## Landscape Referral Response

<b>Application Number:</b>	DA2022/2256
<b>Date:</b>	22/02/2023
<b>Proposed Development:</b>	Demolition works and construction of a mixed use development with basement car parking.
<b>Responsible Officer:</b>	Tony Collier
<b>Land to be developed (Address):</b>	Lot 100 DP 1009880 , 22 Raglan Street MANLY NSW 2095

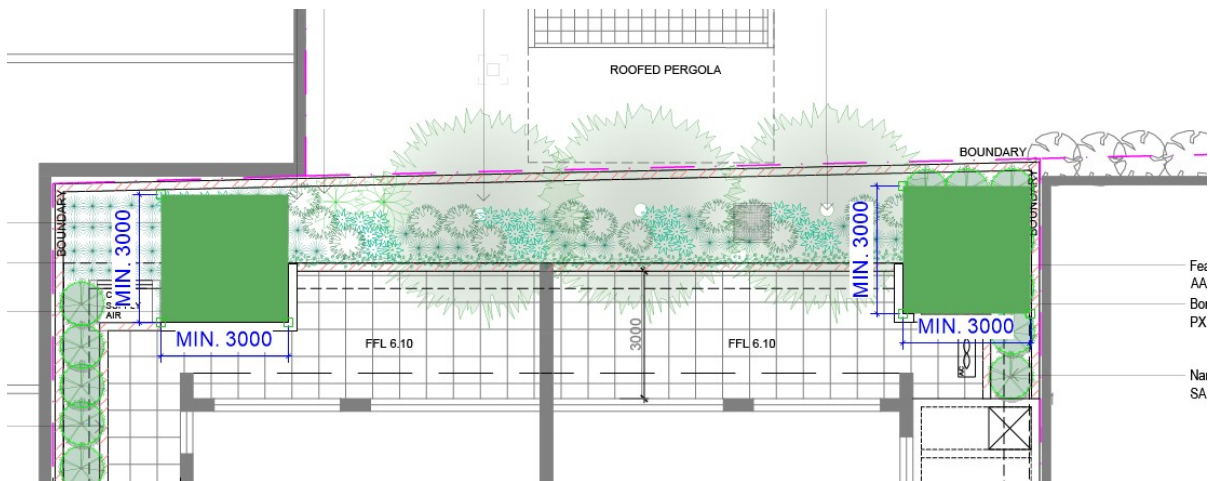
Landscape Referral calculates the available deep soil at approximately 44 square metres (internal measurements). As per the ADG part 3E, the minimum dimension of the deep soil zone shall be 3 metres and a total of 50 square metres for this property. The three trees proposed in this deep soil zone are supported; however, to increase the available soil volume, to help satisfy the ADG part 3E, and to improve the conditions for the proposed trees, this landscaped area shall be slightly increased incorporating on slab landscaping adjacent to the deep soil zone. To achieve this, a 3 x 3 metre area (internal width) shall be provided at both the eastern and western corners of the property, as shown below (to have 1000mm soil depth):

Two trees shall be located in these areas, planted into the deep soil, and the third tree centrally located between the other two. Taller supplementary planting can then be included in-between the trees (*Elaeocarpus reticulatus* 'Prima Donna' or similar) to improve privacy between dwellings. The proposed stormwater infrastructure (pits and pipes) shall not be installed centrally in the deep soil zone, rather installed against the basement shoring or rear boundary.
